To: Kristopher Byrd, Well Construction and Compliance Section Manager
From: Travis Kelly, Well Construction Compliance Coordinator
Subject: Review of Water Right Application G-19236
Date: February 10, 2022

Groundwater Application Review Summary Form

Application # G- 19236

TO: Water Rights Section Date 1/14/2022
 FROM: Groundwater Section Phillip I. Marcy
 Reviewer's Name
 SUBJECT: Application G- 19236 Supersedes review of _____
 Date of Review(s)

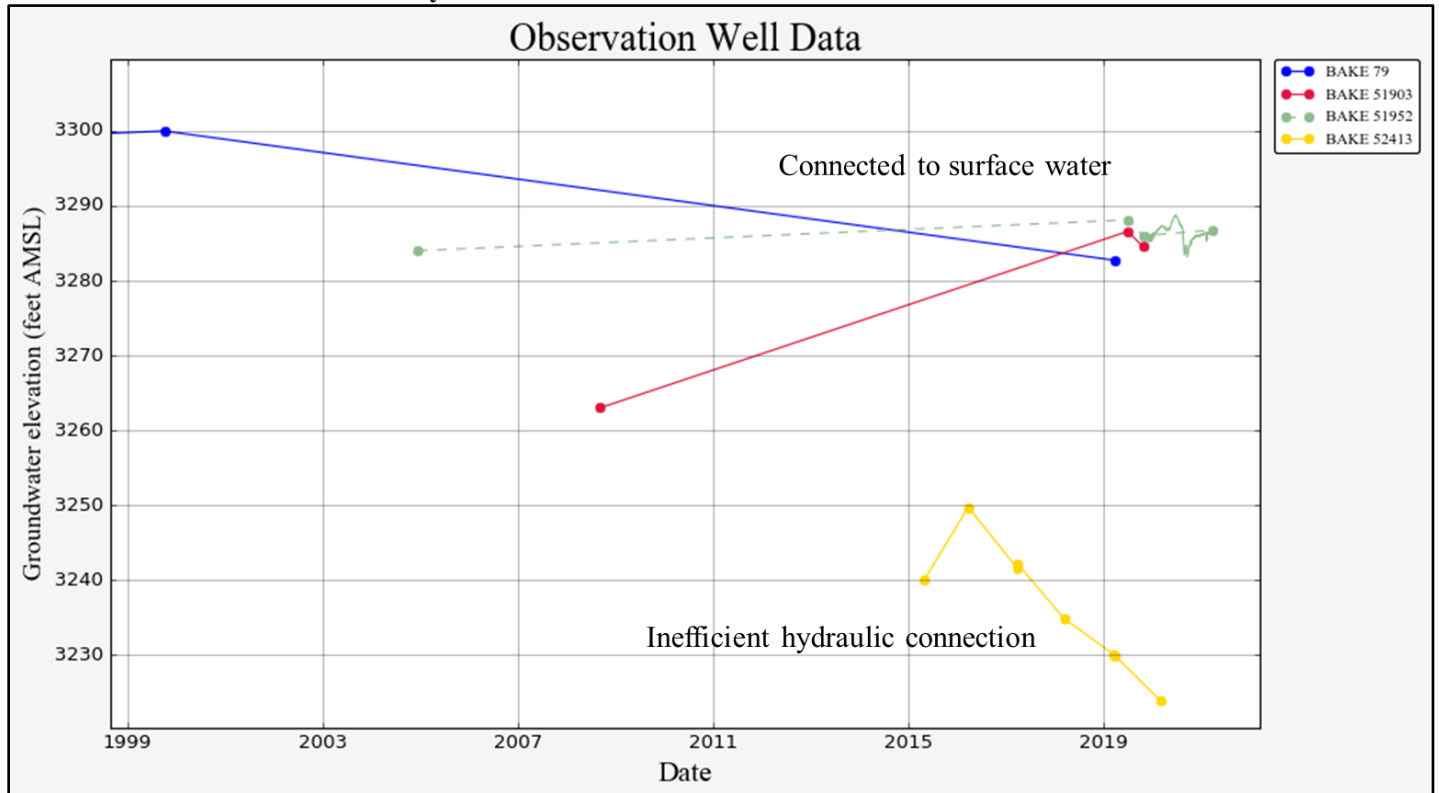
Idealized cross-section for the area of proposed development depicts our conceptual model of the relationship between mapped lithologies (Brooks, 1976) and those reported on driller’s logs. Erosional remnants of Powder River Volcanics in places directly overlay granite, while in other locations is likely that “rock” or “basalt” are used interchangeably and may indicate either Miocene volcanic or Mesozoic metasedimentary rock (Clover Creek Greenstone). Interflow zones in volcanic flow rocks are relatively permeable and produce moderately high yields to nearby wells, while dense flow interiors have very low permeability. In cases where volcanic sequences are laterally extensive and the sequence remains intact, aquifers housed in interflow zones can display high degrees of isolation from surface water and adjacent aquifers, as evidenced by water level trends that diverge from both adjacent aquifers and seasonal patterns of surface recharge. Considering the available evidence, interflow zones within the volcanic sequence here are likely highly dissected by erosion and offset by faulting, in turn creating efficient pathways for groundwater to move to and from these aquifer zones and adjacent unconfined surficial aquifers.

Recent water level data are sparse for the area of interest, but two distinct trends illustrate the impact of hydraulic connection to surface water in addition to providing evidence that the degree of connectivity is largely controlled by local geologic structure. The three wells with water levels between 3,280 and 3,290 feet AMSL have remained fairly stable over the period of record and display seasonal changes in the continuous record of BAKE 51952 (below). Like BAKE 51952, BAKE 52413 is also constructed to produce from fractured zones within granite but displays much different behavior. The year-upon-year declines reported in this well illustrate limited recharge to this aquifer, thus lack of hydraulic connection to surface water. The difference between these two situations is likely the degree to which fractures in bedrock are connected to adjacent aquifer materials in the adjacent sedimentary sequence.
